CITY OF ALBUQUERQUE

RE: **Abundant Life Gymnasium**
2851 Arenal Rd SW
Revised Grading and Drainage Plan
Engineers Stamp Date 4/12/16 (M10D016)

GRADING AND DRAINAGE PLAN

SUBJECT: ABUNDANT LIFE GYMNASIUM
Updated Grading and Drainage Plan (M10-D0006)

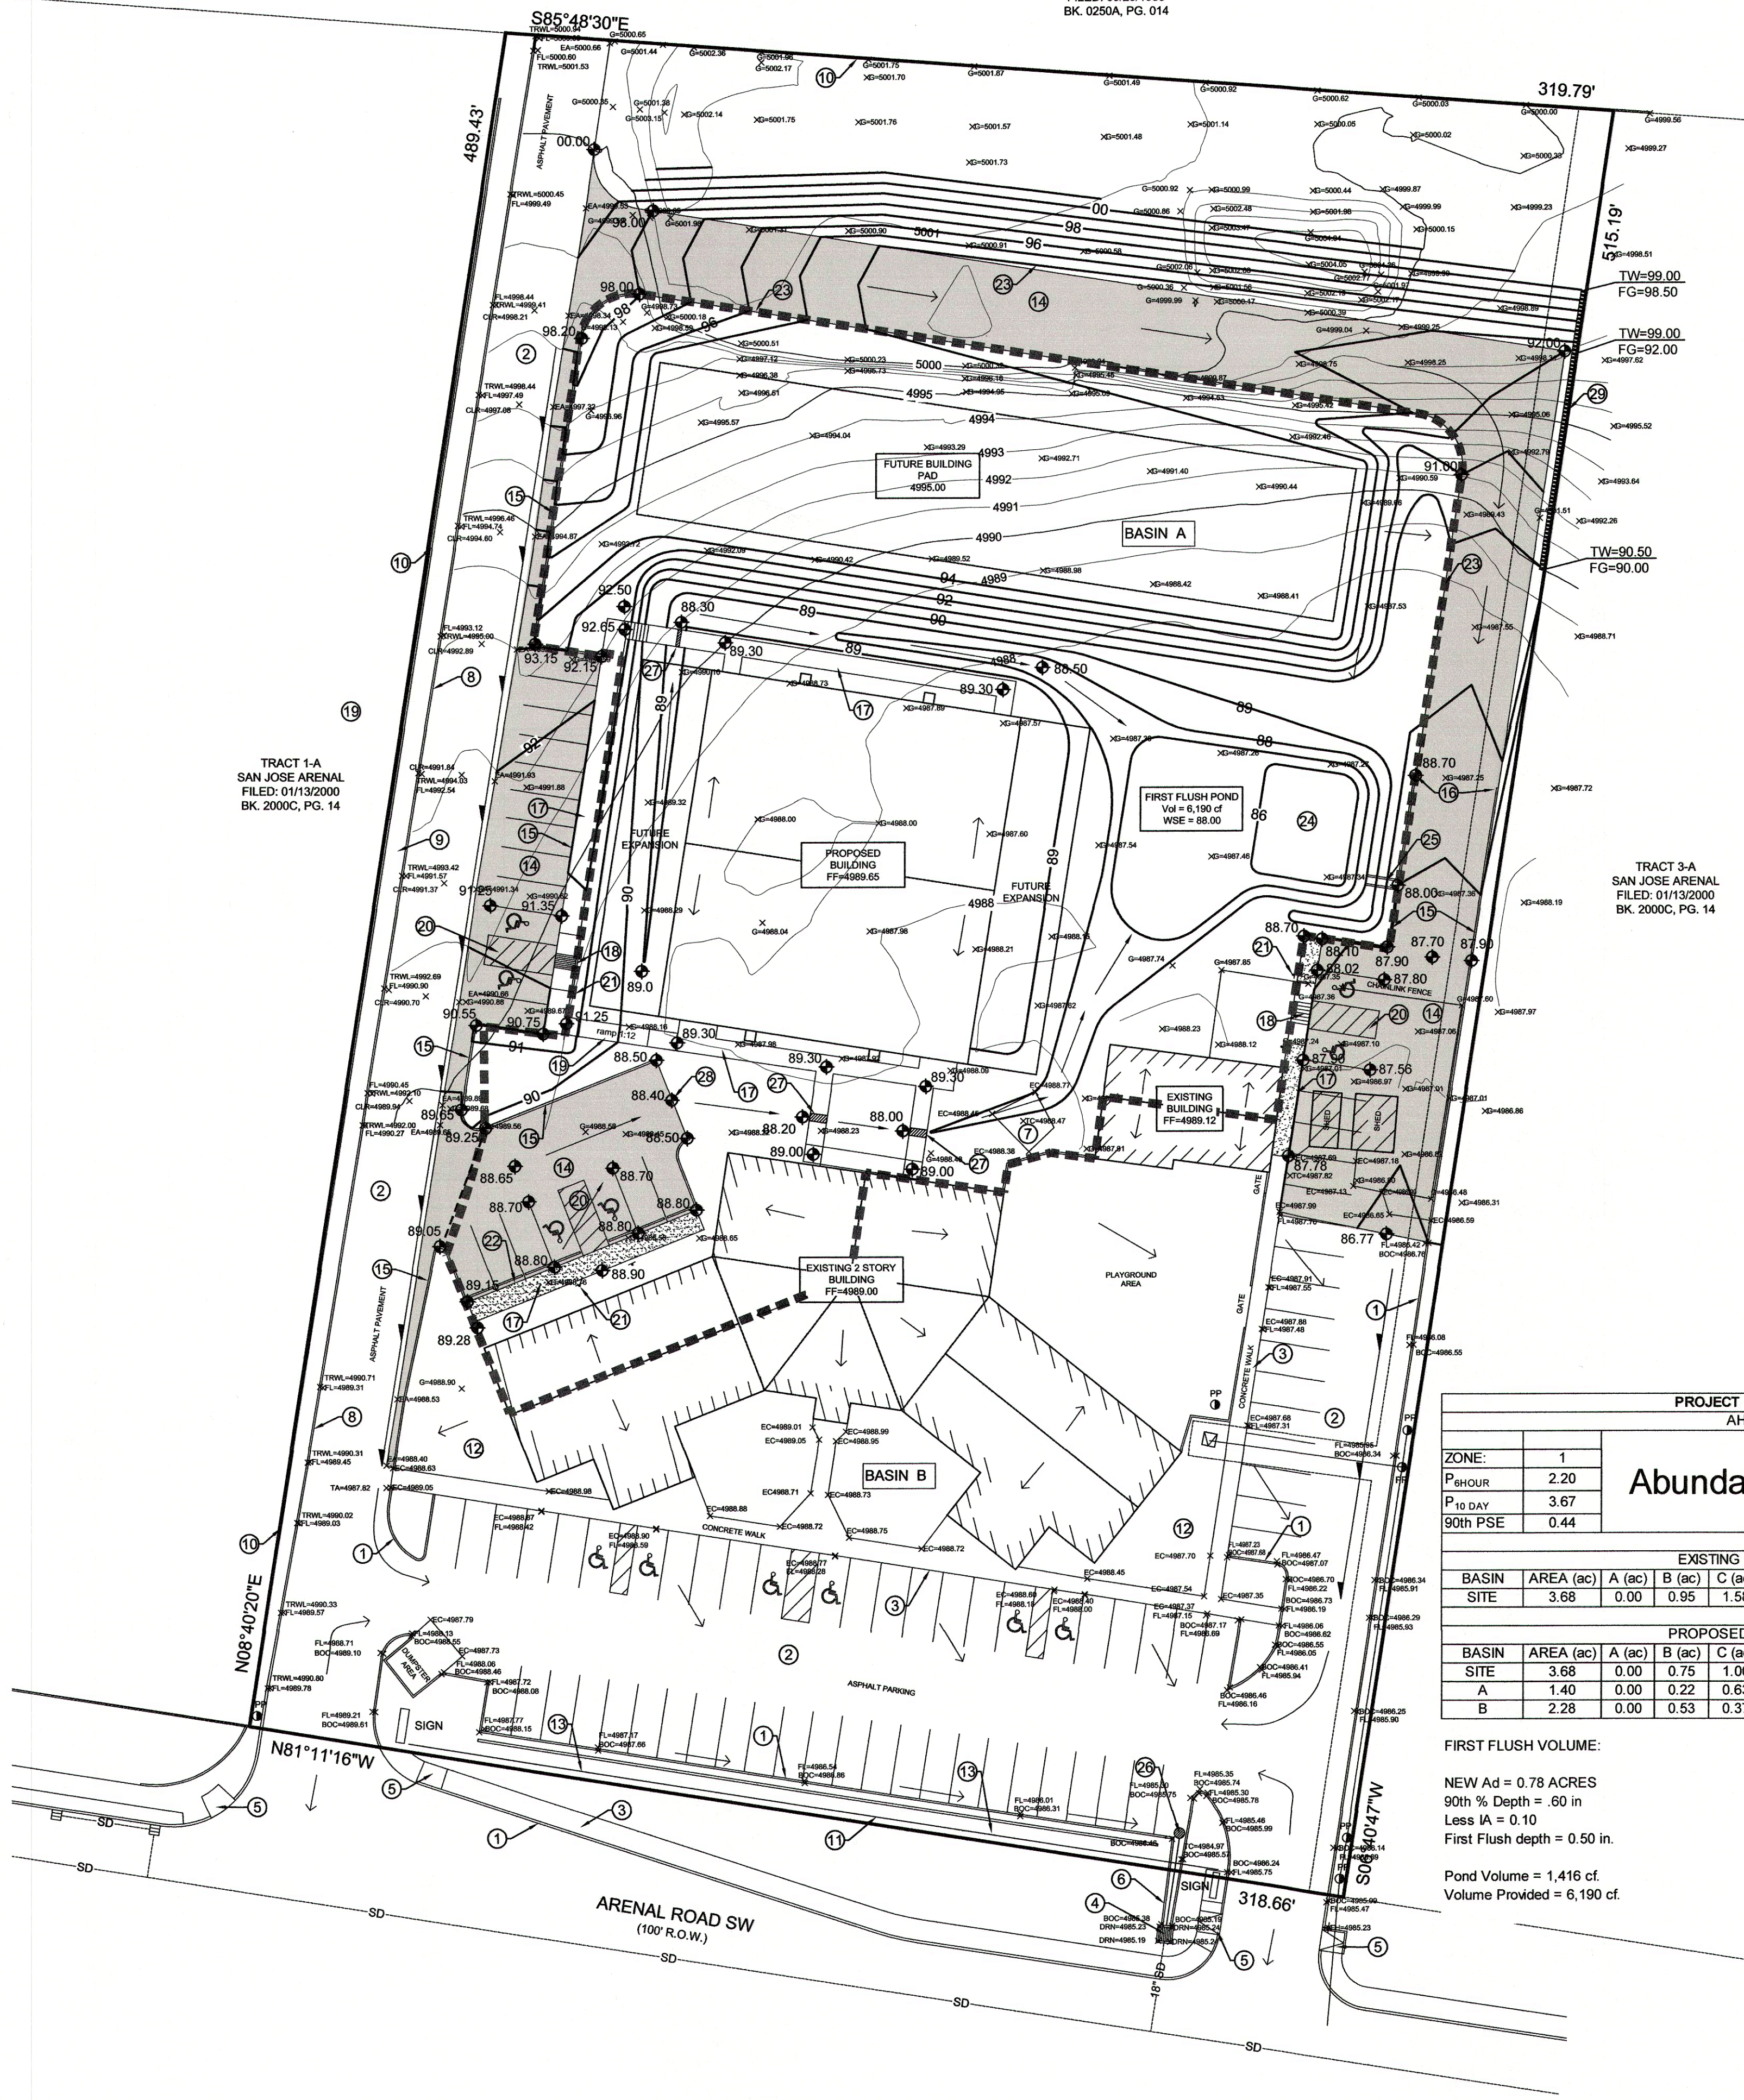
Based upon the information provided in your submittal received 4/20/2016, the above referenced Grading and Drainage Plan is acceptable for Grading Permit and Building Permit.

Attach a copy of this approved plan to the construction sets in the permitting process prior to sign-off by Hydrology. This plan is also approved for SO-19. Contact Jason Rodriguez at 235-8016 to schedule an inspection for the tie into the back of the inlet before and after concrete is placed. A separate Excavation/Barricading Permit is required for SO-19 construction within City ROW. A copy of this approval letter must be on hand when applying for the permit.

Prior to Certificate of Occupancy release, Engineer Certification per the DPM checklist will be required.
